SUBJECT: ISSUANCE OF AMENDMENTS (TAC NOS. 77812 AND 77813)

The Commission has issued the enclosed Amendment No. 81 to Facility Operating License No. NPF-11 and Amendment No. 65 to Facility Operating License No. NPF-18 for the LaSalle County Station, Units 1 and 2, respectively. The amendments are in response to your application dated October 10, 1990, as supplemented October 16, 1991.

The amendments modify the Technical Specification (TS) requirements for the High Pressure Core Spray (HPCS) system by permanently aligning the HPCS suction to the suppression pool and removing all TS requirements for aligning the HPCS suction to the condensate storage tank. In addition, containment isolation requirements are added for the new Reactor Core Isolation Cooling (RCIC) full flow test line to the suppression pool.

LASALLE COUNTY STATION, UNIT 1

BASES FIGURE B 3/4.6.2-1

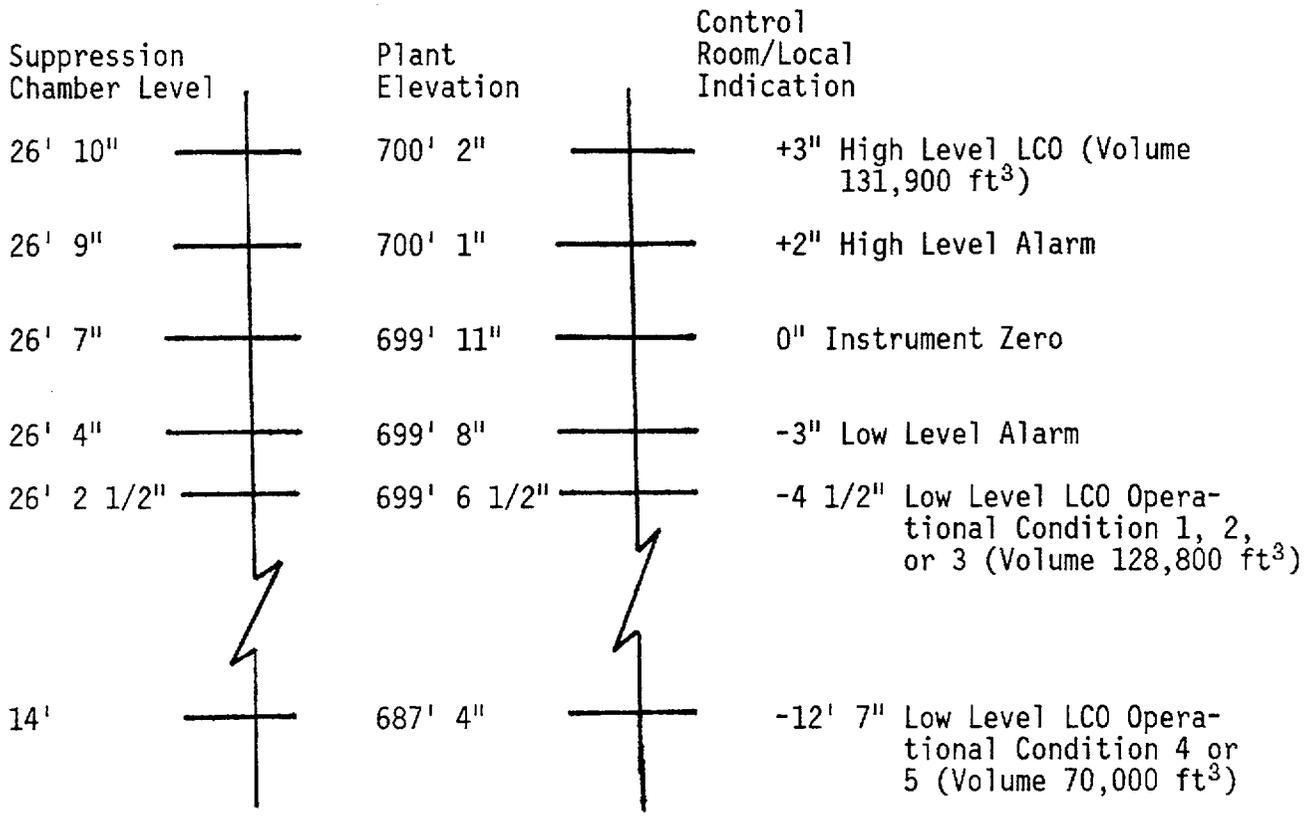
- Remove the reference to the CST from the bases of TS 3/4.5.1 and 3/4.5.2.
- Remove the reference to the HPCS suction valve transfer from Bases Figure B 3/4.6.2-1.

FIGURE 1

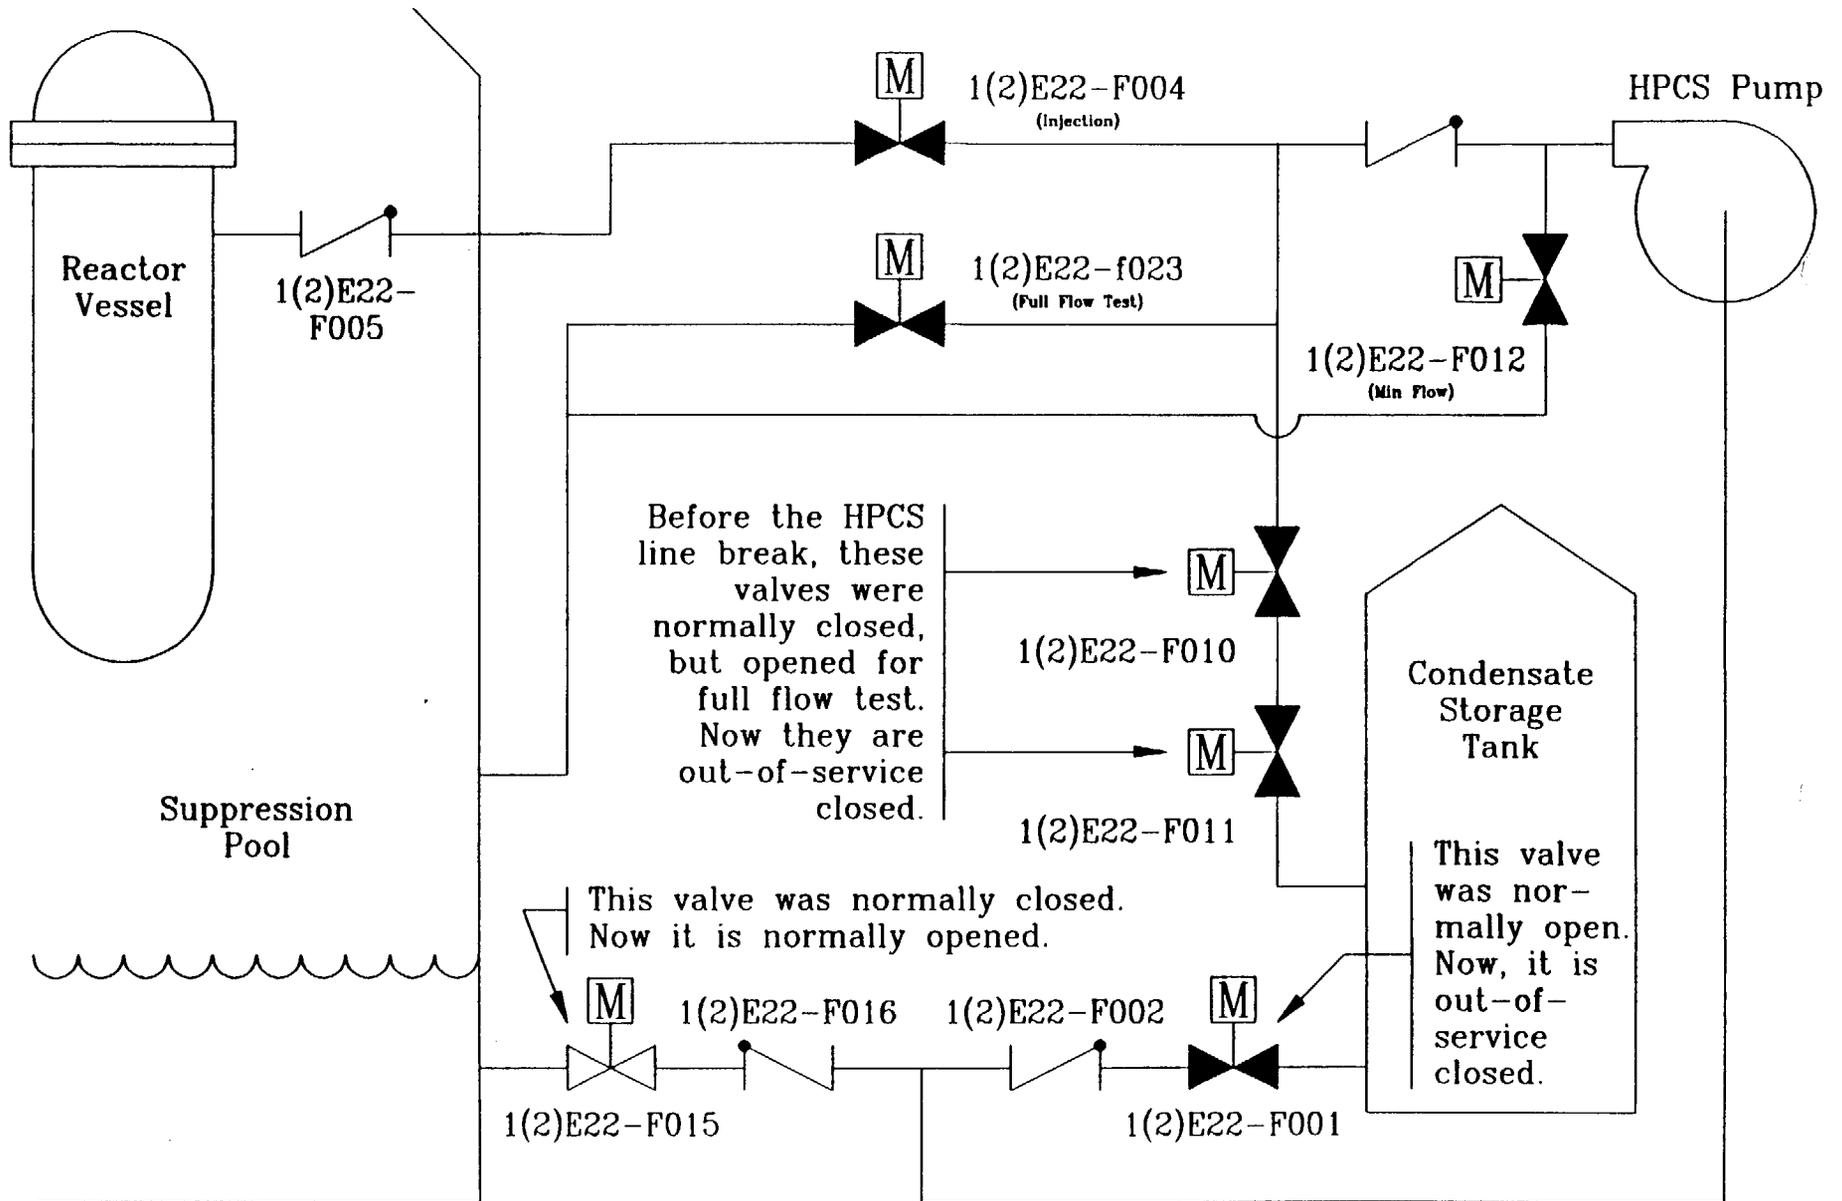
Since the discovery of leakage from the HPCS system suction and full flow test lines to the CST, these lines have been isolated and administratively controlled. The licensee's HPCS system modifications will permanently isolate the suction and test lines. As a result, the current TS requirements for the HPCS system suction flowpath transfer will no longer be required. The licensee proposed the following changes to the TS in their October 10, 1990, submittal.

The HPCS system is designed to be normally aligned to take suction from the CST, which provides an additional source of primary system water. The suction valves to the suppression pool would normally be closed in this configuration. The UFSAR states that credit for this water is not taken in the accident analysis; therefore, the CST is only expected to function during normal plant conditions and performs no safety function. Since no credit for the water in the CST is taken in the LaSalle accident analysis, the staff has concluded that removal of the associated requirements in the TS is acceptable. On this basis the staff has reviewed the proposed TS changes for removal of CST requirements described above and finds them acceptable.

Figure 2
 RCIC Full Flow Test Return To Suppression Pool

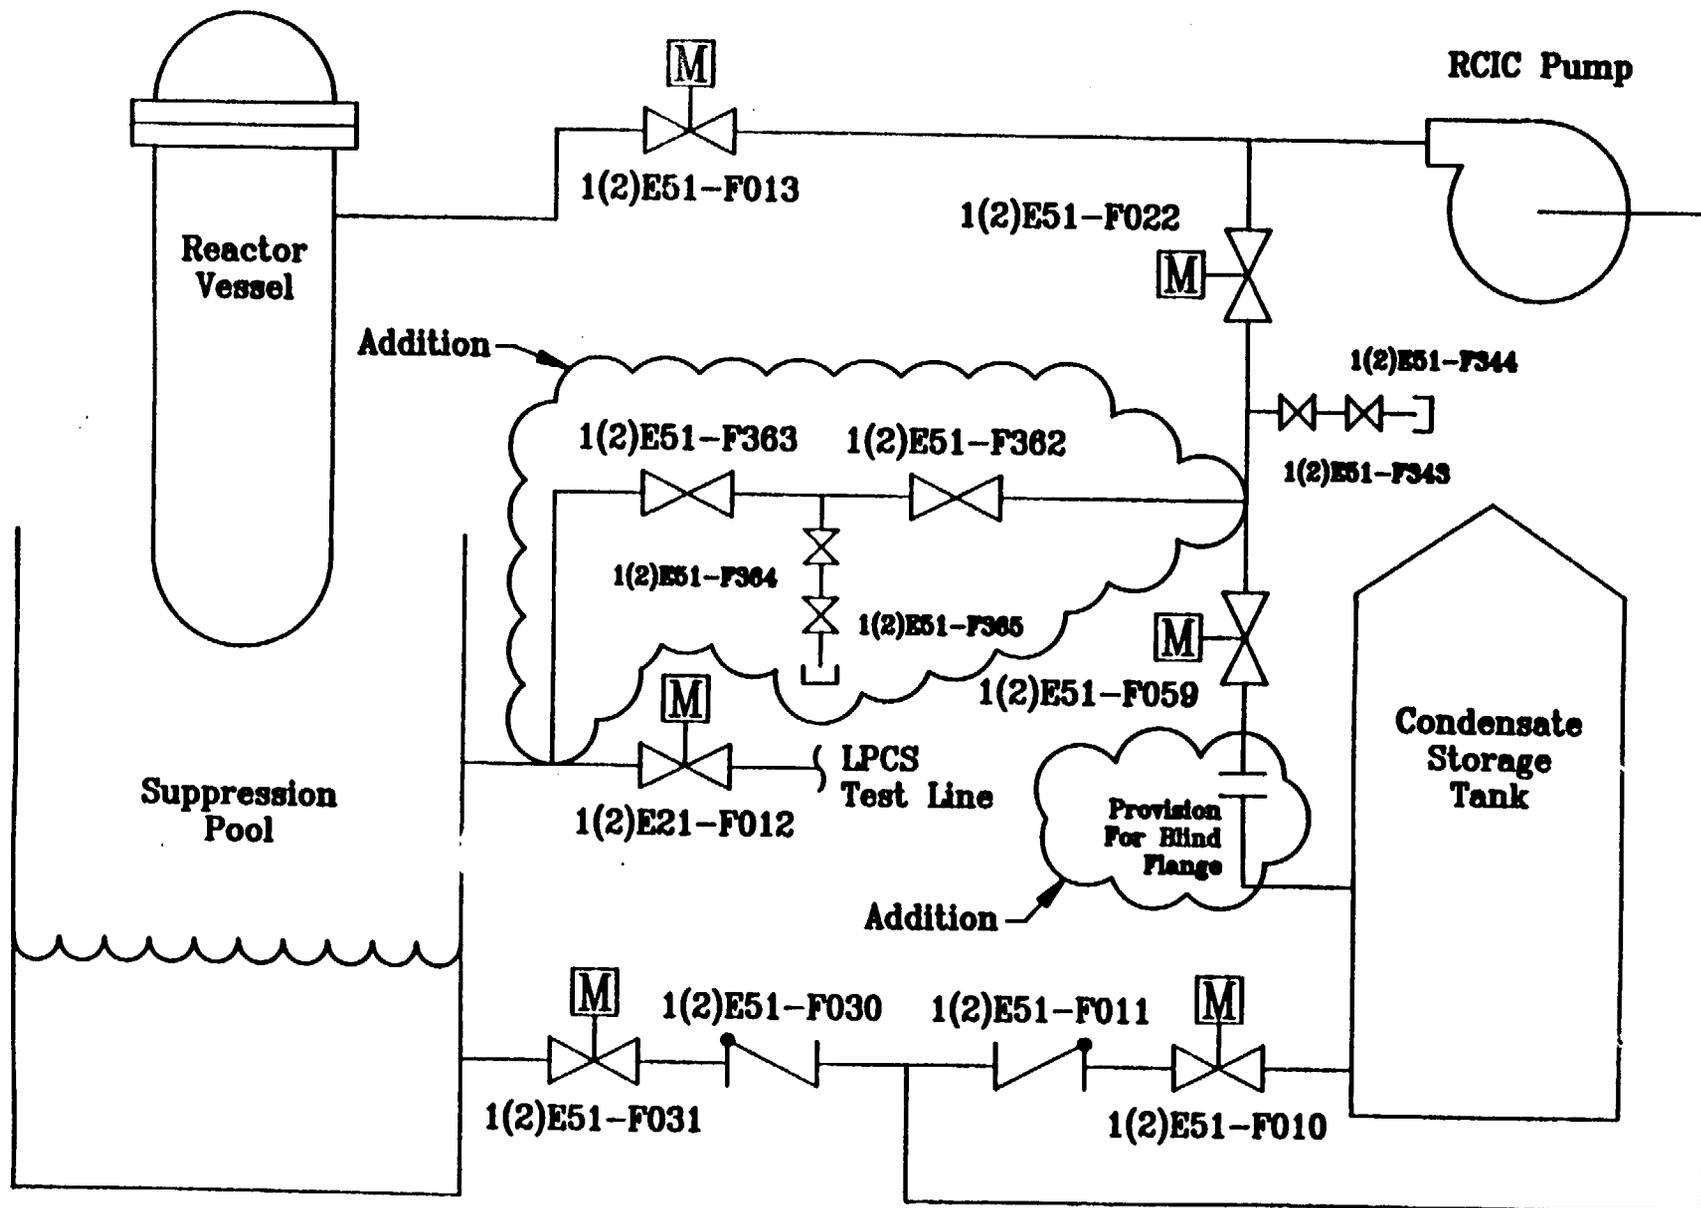
The licensee's planned modification to install an RCIC system full flow test line to the suppression chamber is being performed to minimize the impact on plant operations of any future RCIC underground piping failure. TS 3.7.3 requires the RCIC system to be operable and to have an operable flow path from the suppression pool to the reactor vessel. A failure of the RCIC underground lines to the CST would not necessarily render the system inoperable immediately because the specified flow path from the suppression pool to the reactor would be unaffected. However, if a failure involved the full flow test line to the CST, performance of the quarterly pump performance surveillance would be difficult (Surveillance Requirement 4.7.3.b). Under these conditions the only means of performing this test would be by actual injection to the reactor vessel. Since an RCIC system injection causes a trip of the main turbine and the feedwater pump turbines, reactor power would have to be reduced and the turbines would have to be shut down prior to performing the surveillance.

This would be a costly option since it would require a power reduction outage every three months until repairs or modifications to the underground piping could be completed. The licensee's preferred and planned option (refer to Figure 2) is to install (1) an additional full flow test line to the suppression pool for the RCIC system, and (2) to install a flanged joint downstream of the 1(2)E51-F059 valve where a blind flange can be installed. This option will increase the RCIC system flexibility, such that an underground piping failure would have a minimal impact on plant operation and safety. This

modification is scheduled to be installed during the next refueling outage for each unit. (Unit 1, October 1992, Unit 2, January 1992.)

As a result of these planned modifications, the licensee has proposed TS changes which add the RCIC system full flow test valves 1(2)E51-F059, 1(2)E51-F022, 1(2)E51-F362, and 1(2)E51-F363 to Table 3.6.3-1, "Primary Containment Isolation Valves." The licensee proposed the following changes to the TS in their October 10, 1990, submittal to be implemented prior to startup from the next refueling outage for each unit.
